CITY OF ROLLINGWOOD BOARD OF ADJUSTMENT MEETING AGENDA

Tuesday, June 22, 2021

- 3. Public hearing, discussion and possible action on a variance from the City’s Code of Ordinances, Section 107-35, no tennis court shall be constructed or maintained in the area between the rear setback line and the rear lot line for the Western Hills Athletic Club at 4801 Rollingwood Drive
- 4. Public hearing, discussion and possible action on a variance from the City’s Code of Ordinances, Section 107-242 regarding the requirement of the 30 foot greenbelt zone for each lot in a park district which abuts a lot in a residential district for at the Western Hills Athletic Club at 4801 Rollingwood Drive
- 5. Public hearing, discussion and possible action on a variance from the City’s Code of Ordinances, Section 107-422, a nonconforming structure may not be altered to increase the extent of the nonconformity for at the Western Hills Athletic Club at 4801 Rollingwood Drive

The above-referenced report and plans were reviewed by the City for compliance with City Zoning Ordinances. We are providing the following comments based on a cursory review of the submittal; additional comments may be generated upon th

PROPOSED DRAINAGE AREA CALCULATIONS

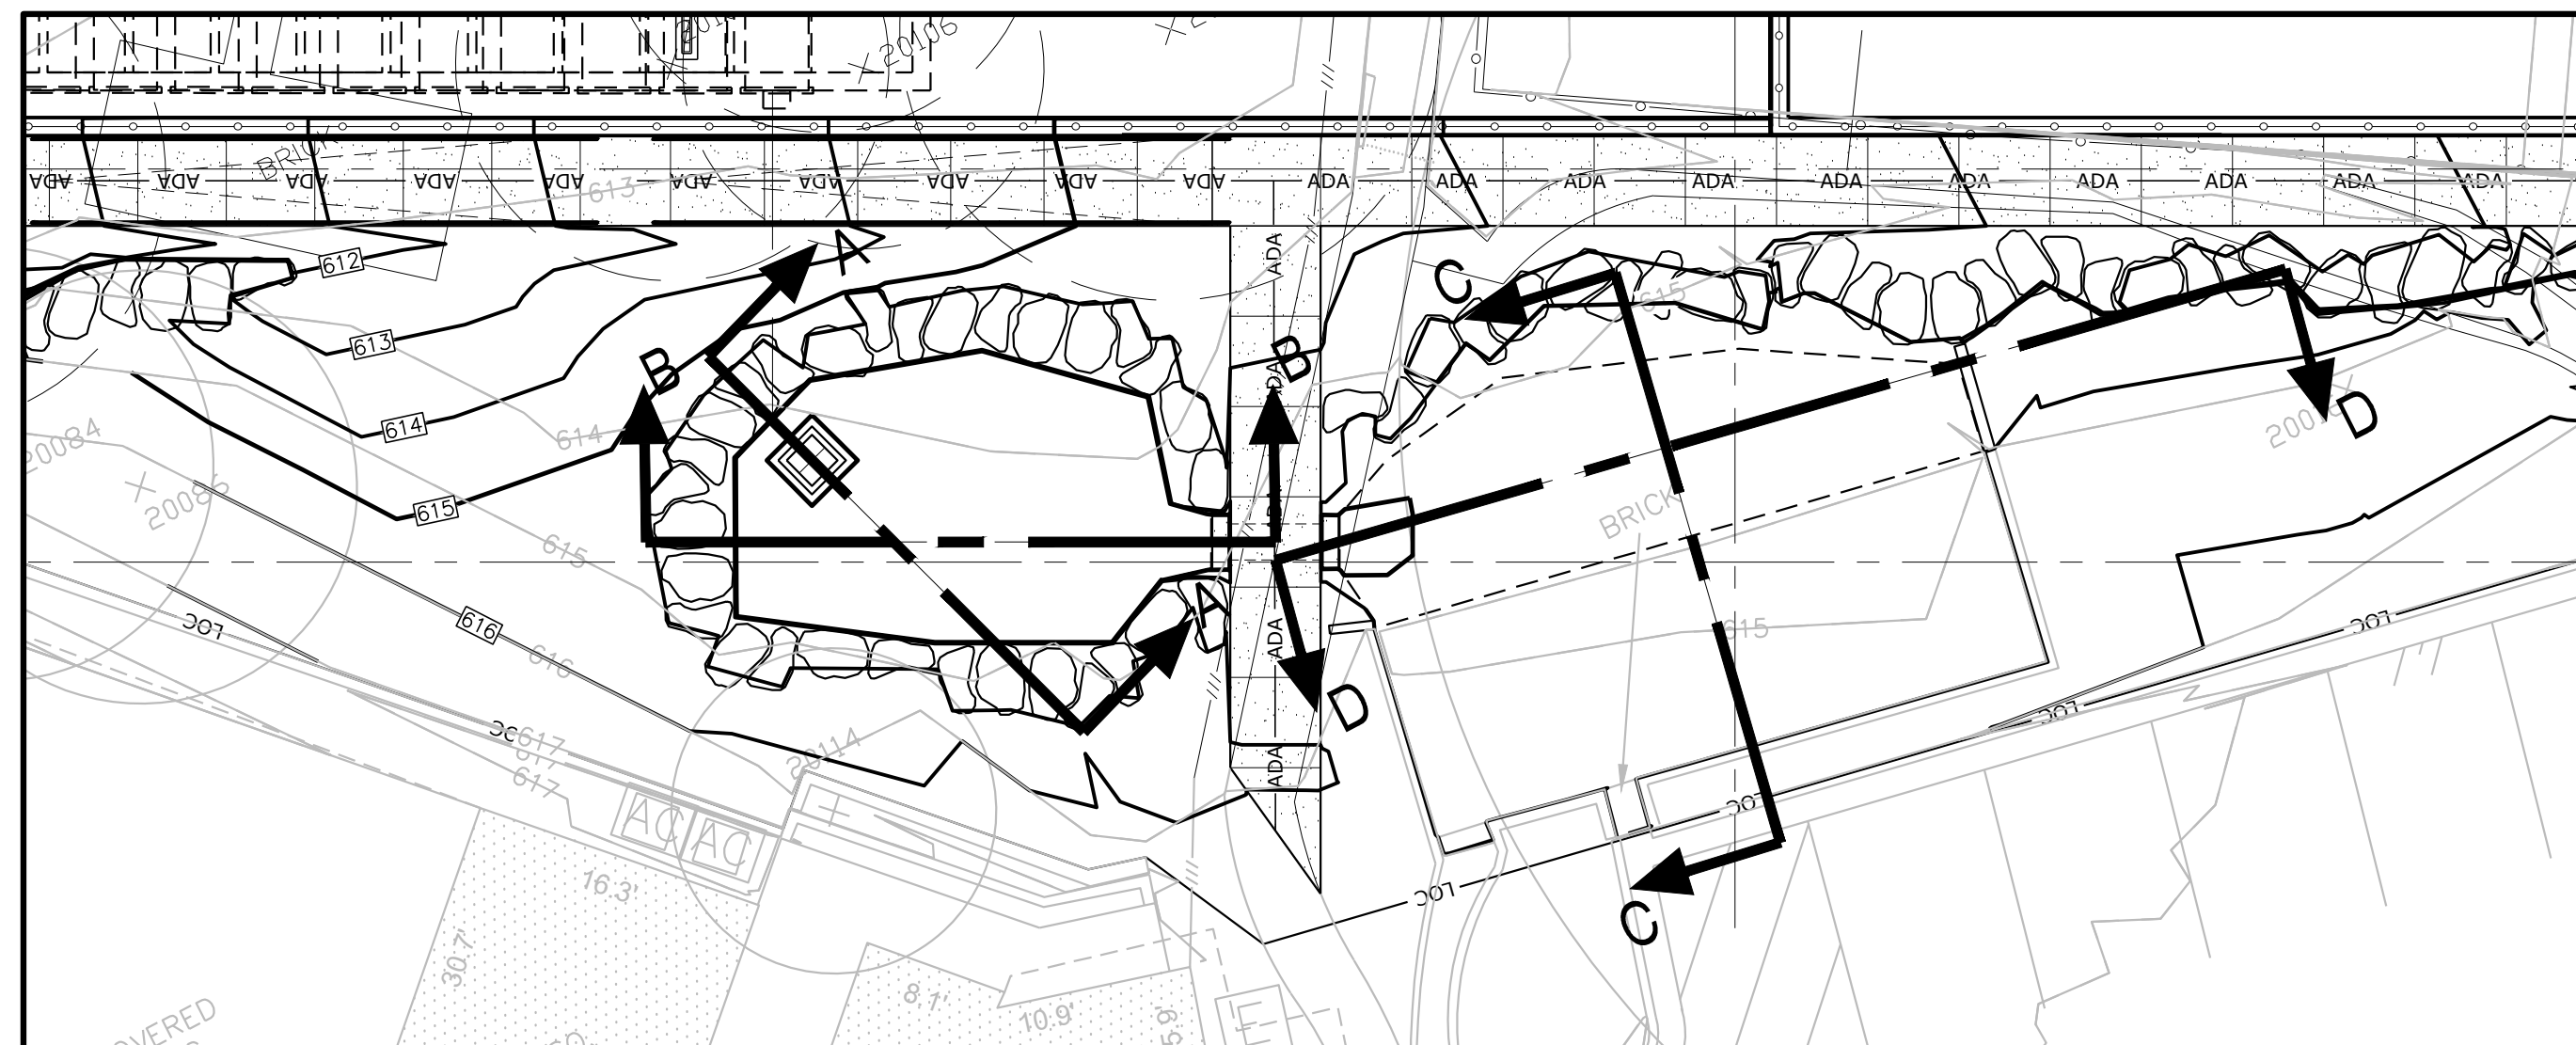
acres and the impervious cover is 1.60 acres or 51.6% impervious cover. The cover sheet indicates the site will have 50% impervious cover and page 21 of 26, water quality sheets, shows the project area is 3.21 acres with 1.60 acres of impervious cover, or 50%.
